**CALPINE
BLUE HERON
ENERGY CENTER**

Sufficiency Responses

Re: Calpine Construction Finance Company, L.P.
Blue Heron Energy Center
Site Certification Application No. PA00-42
DOAH Case No. 00-4564EPP
Responses to Agency Sufficiency Comments

FIGURE 6.3.1-1. (REV. 1 1/16/02)
 LOCATION OF PROPOSED WATER SUPPLY PIPELINE

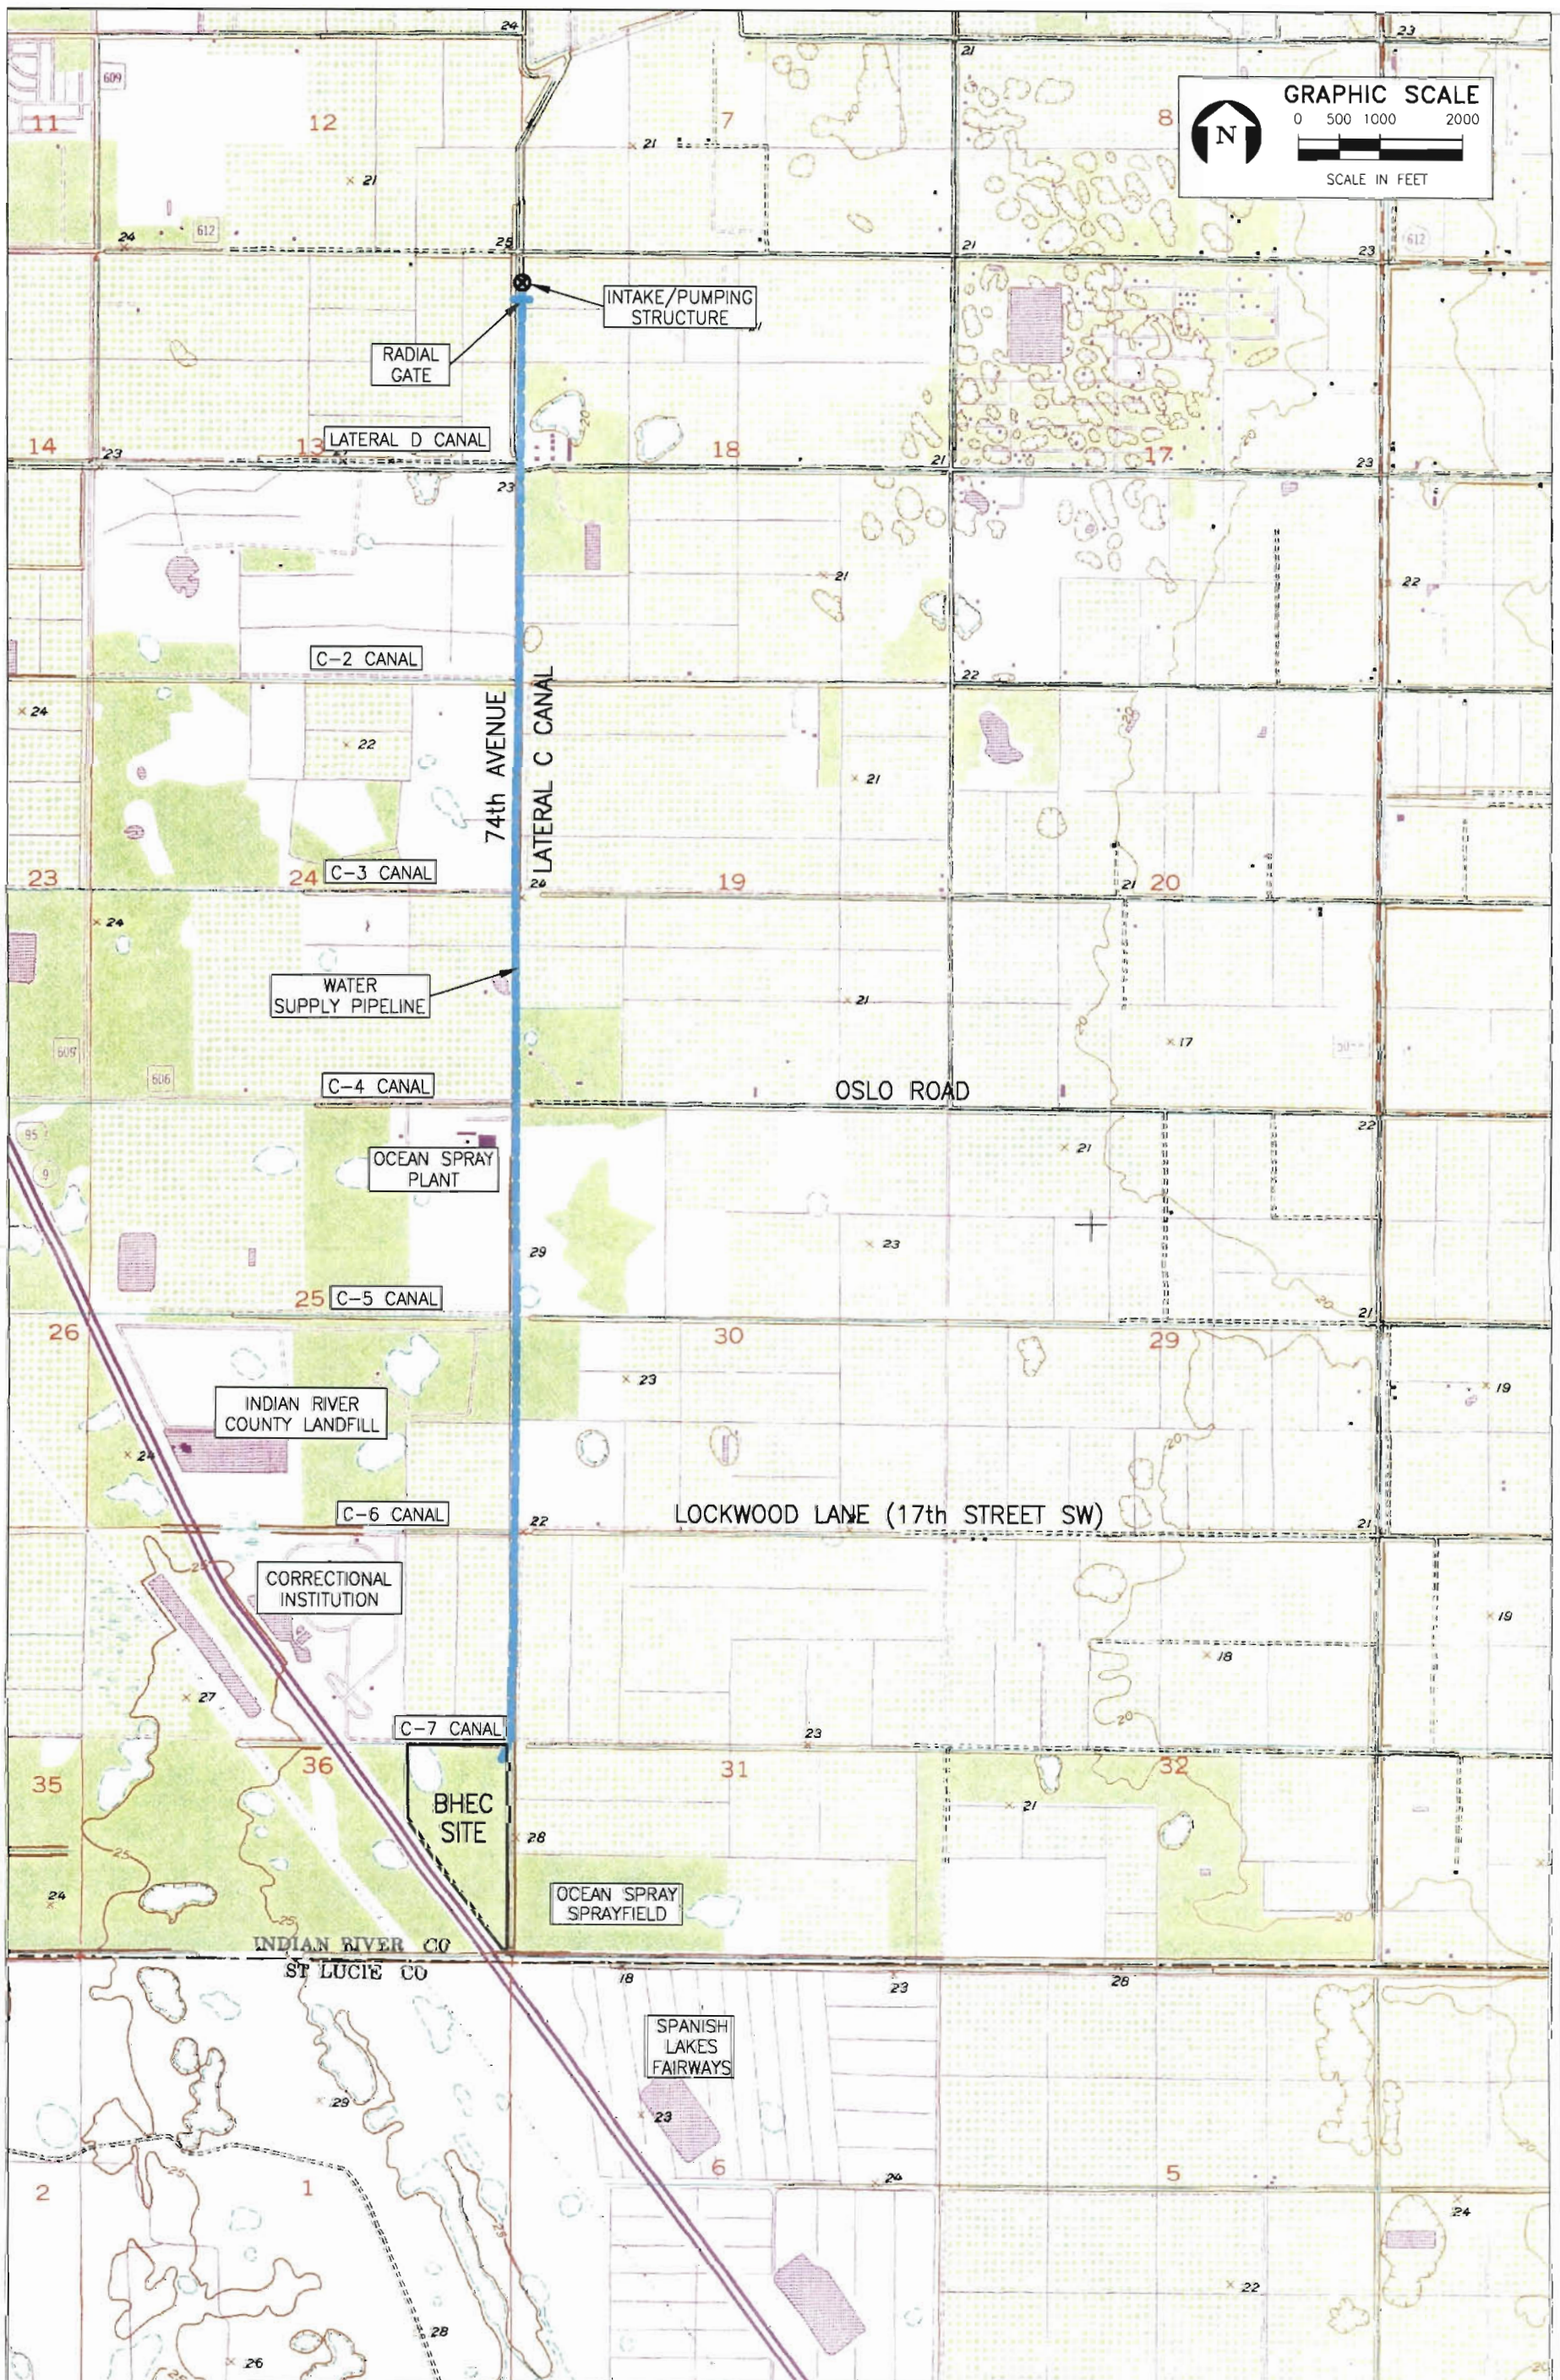
Please add to Figure 1 or create a new drawing which clearly reflects the location of the water pump station and pipeline route from the Lateral C Canal to the BHEC site. Section 6.3.1 states that the entire route follows existing roadway and IRFWCD canal right-of-way. However, it does not identify if wetlands are found within the 3.5-mile stretch between the Lateral C Canal and the BHEC site. Please clarify and revise the plan view drawing to reflect wetland locations. Will any of the pipeline be installed by directional drill? If the area will be trenched using a backhoe, where will spoil temporary be placed for the installation and testing of the pipeline.

There are no state jurisdictional wetlands that will be impacted by the construction of the approximately 3.5-mile pipeline between the plant site and Lateral C Canal. The attached revised Figure 6.3.1-1, Location of Proposed Water Supply Pipeline, from Section 6.3.1 of the SCA, indicates the location of the water pump station and pipeline route. This figure has been revised to indicate the location of IRFWCD canals that are in the vicinity of the proposed pipeline. These canals will not be impacted by the installation of the proposed water pipeline. Directional drilling is not anticipated at any of the perpendicular canal crossings.

Materials removed from the trench will be temporarily side cast into adjacent upland areas during the construction and testing period of the proposed pipeline.

FIGURE 2A. PRE-DEVELOPMENT DRAINAGE

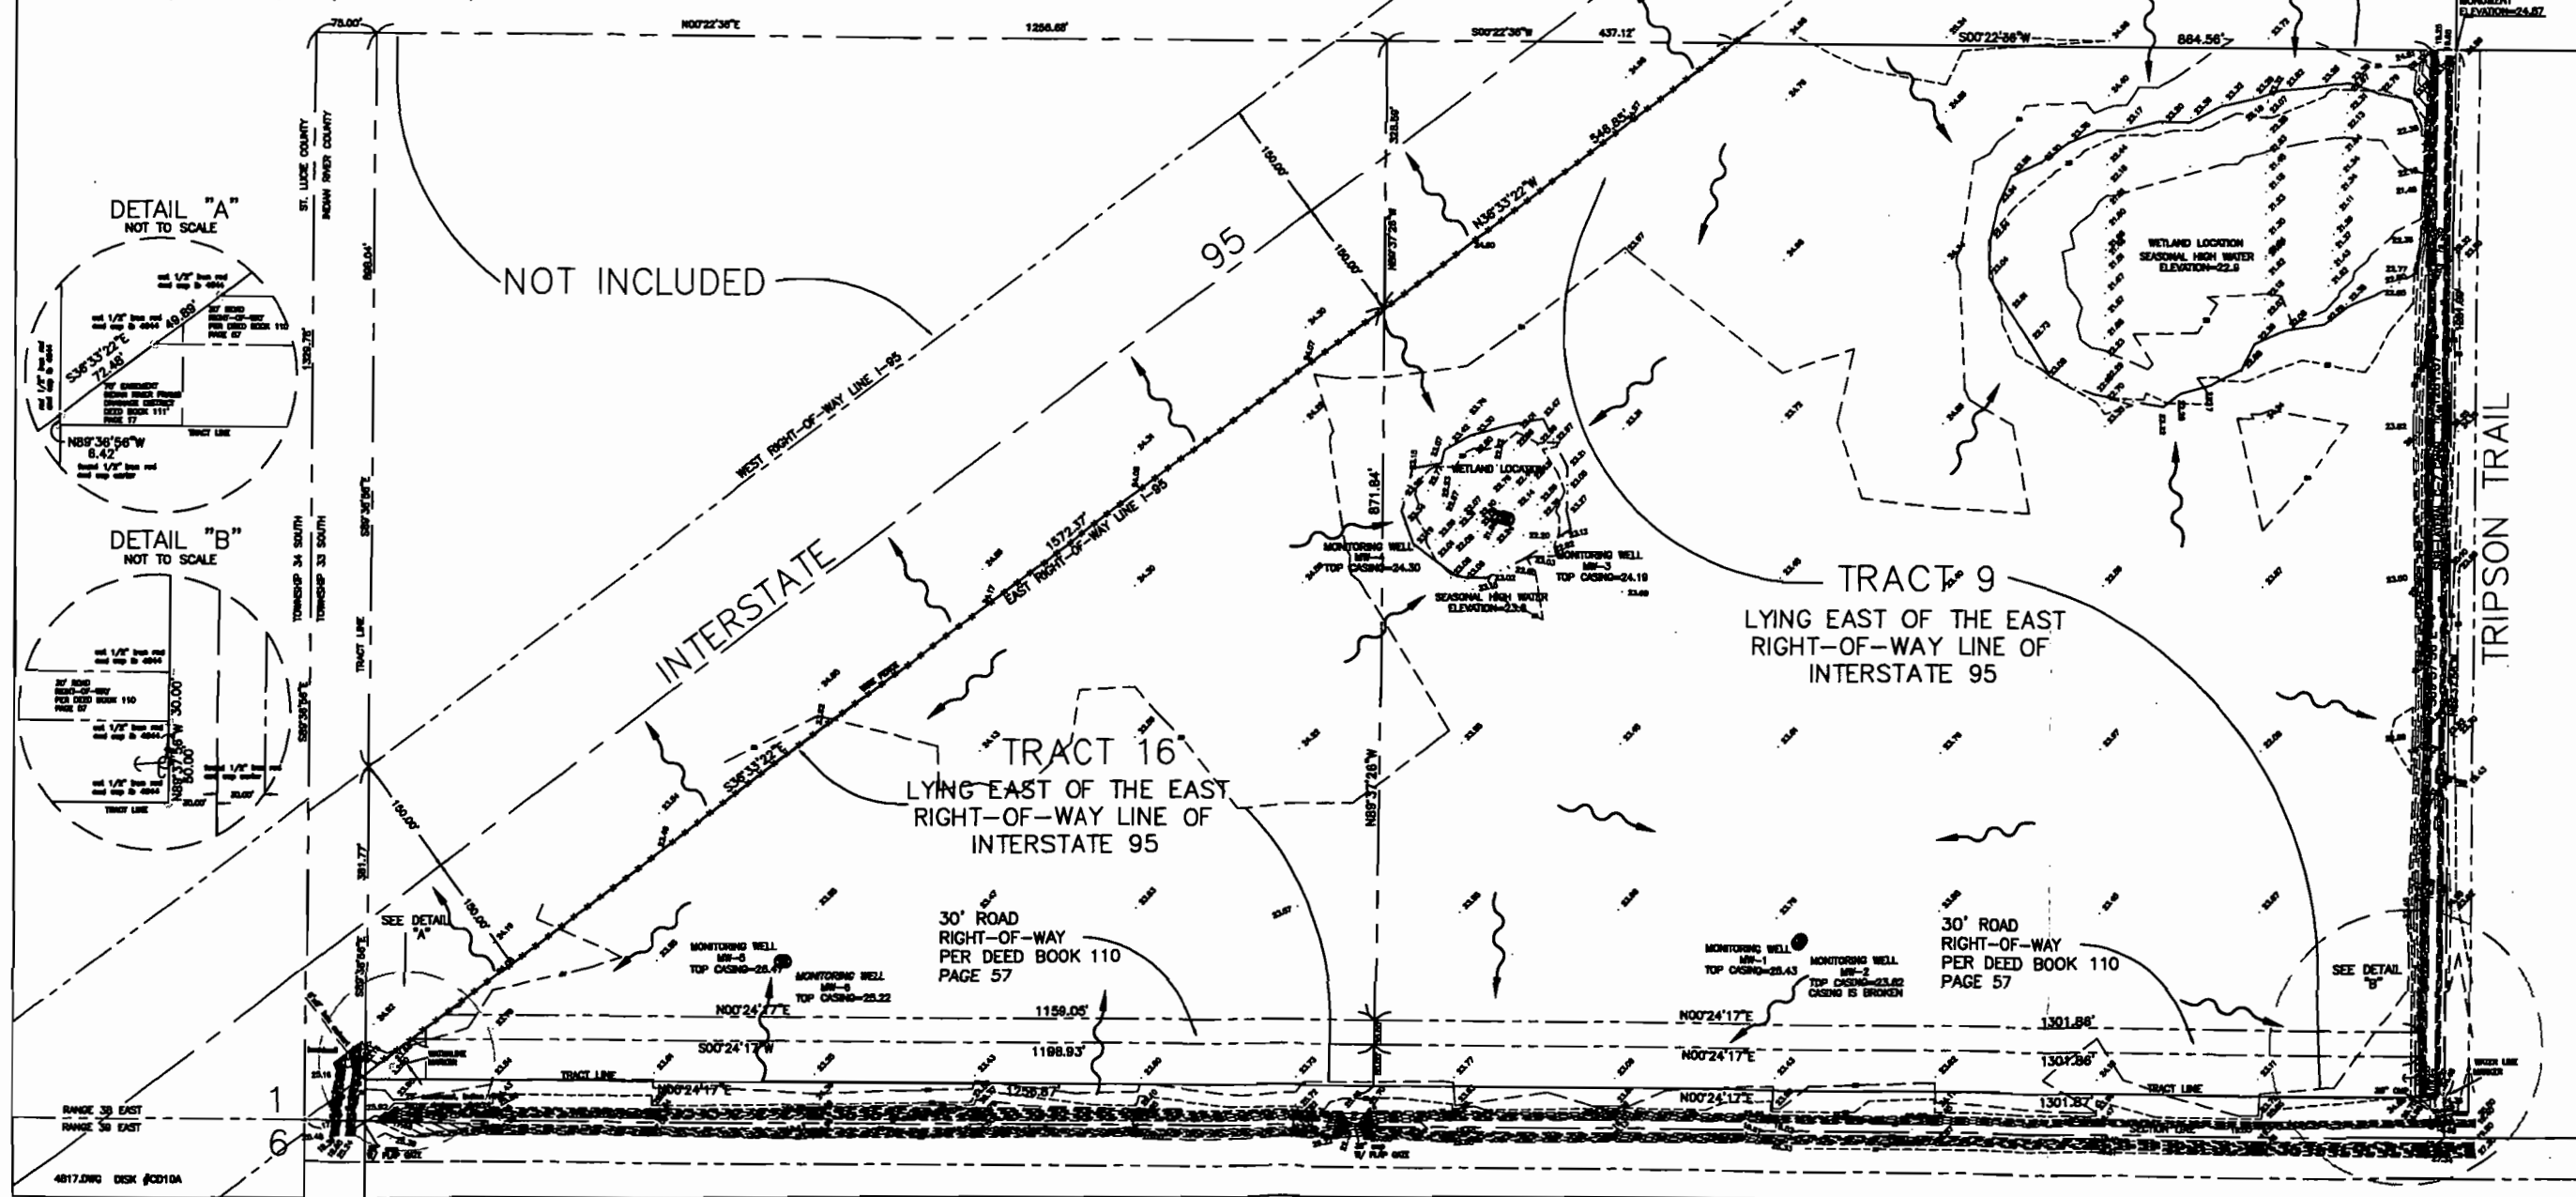
Provide the pre-development drainage patterns, via directional flow arrows to a scaled plan drawing, including points of discharge for existing site drainage and drainage basin boundaries. In addition, provide off-site drainage area and flow patterns at the property boundaries and across the project site.

Please refer to Figure 2A (attached), Pre-Development Drainage, for pre-development drainage patterns and directional flow arrows.

FIGURE SJRWMD-1.
MODEL CONFIGURATION

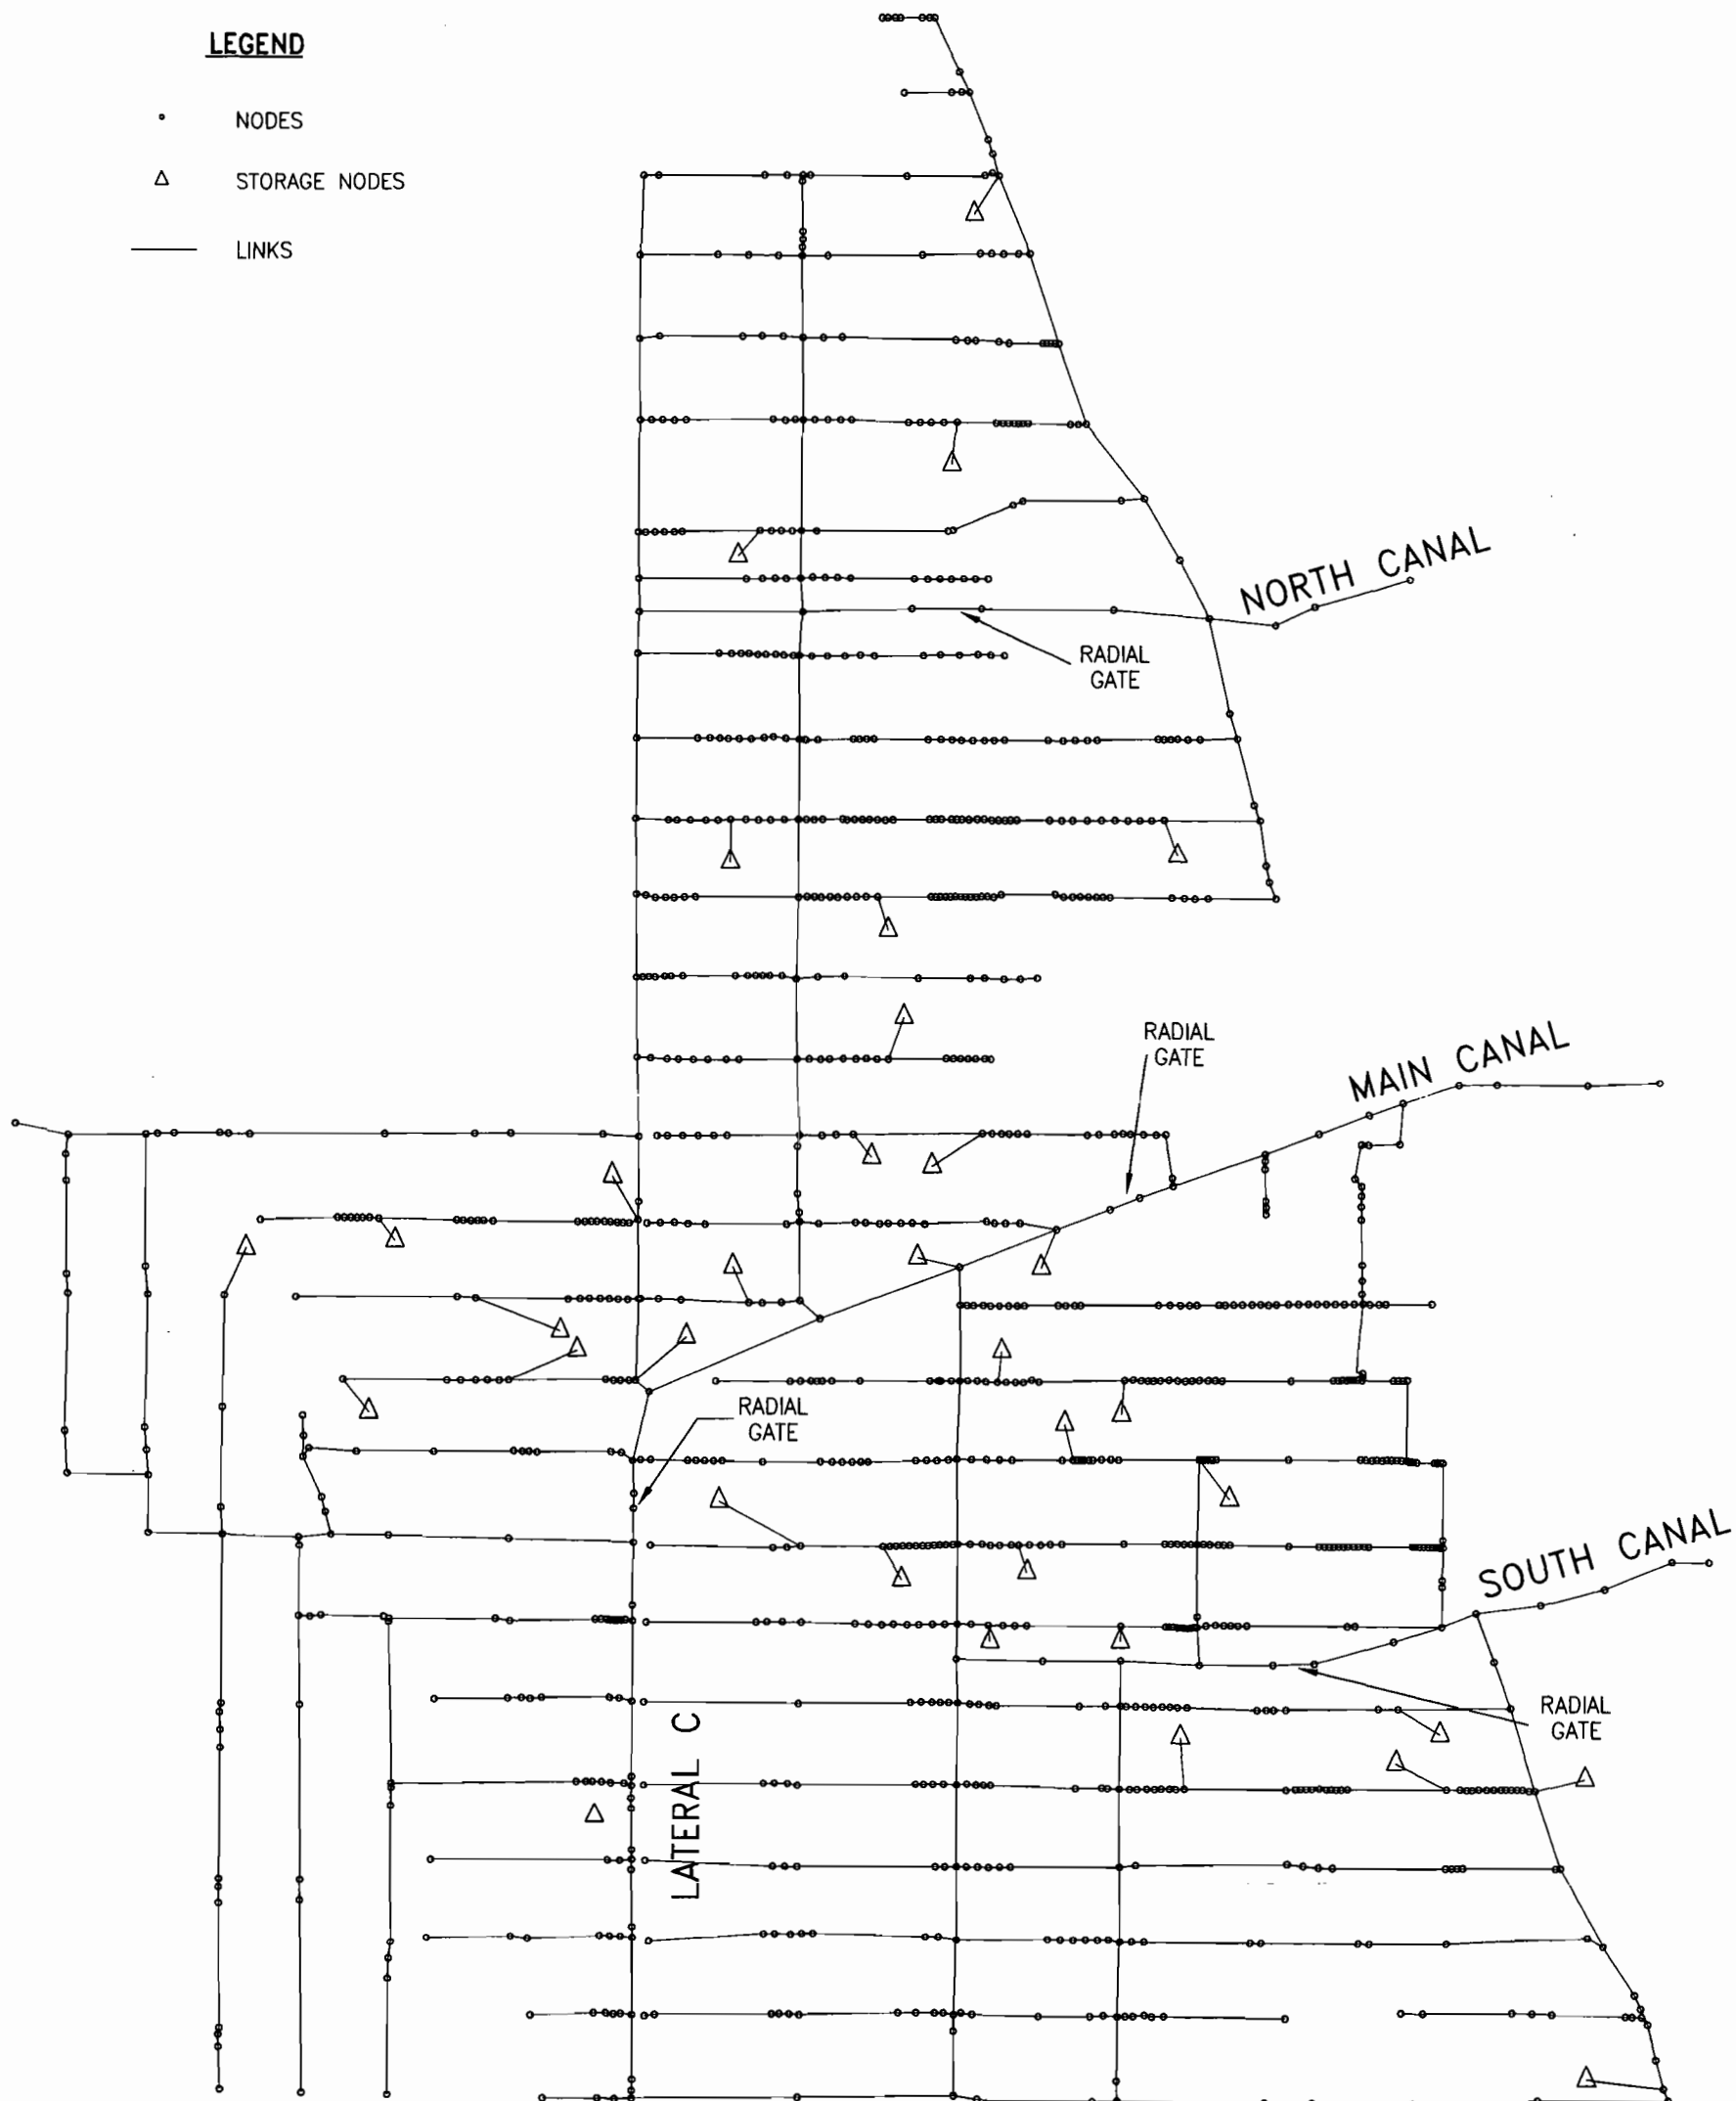
It is our understanding that Calpine—Blue Heron Energy Center is currently working with the Indian River Farms Water Control District, Indian River County, and the SJRWMD to prepare a comprehensive surface water model for the Indian River Farms Water Control District. Please provide surface water modeling which shows the expected drawdown associated with the proposed surface water use. The modeling should evaluate the drawdown due to proposed withdrawals and confirm that existing legal uses are not adversely impacted. If a determination is made that there is a potential for the consumptive use to adversely effect water level stages, vegetation, or crops on lands not owned or controlled by the applicant, then describe how these impacts would be avoided and/or mitigated. [Paragraphs 10.2 (e), (f), (g) & (p) and 10.3 (b) & (d), A. H.]

Calpine has expended significant efforts and resources to develop a comprehensive storm water management model for the area of IRFWCD with the cooperative efforts of Indian River County, SJRWMD, City of Vero Beach, and IRFWCD. Calpine's development of this model has been very beneficial to the County and IRFWCD, since it is currently being used by SJRWMD to evaluate alternatives and develop the master storm water management plan for the east Indian River County watershed.

Visual SWMM 2000 was used to develop the model. The model configuration is shown in the attached Figure SJRWMD-1, which included:
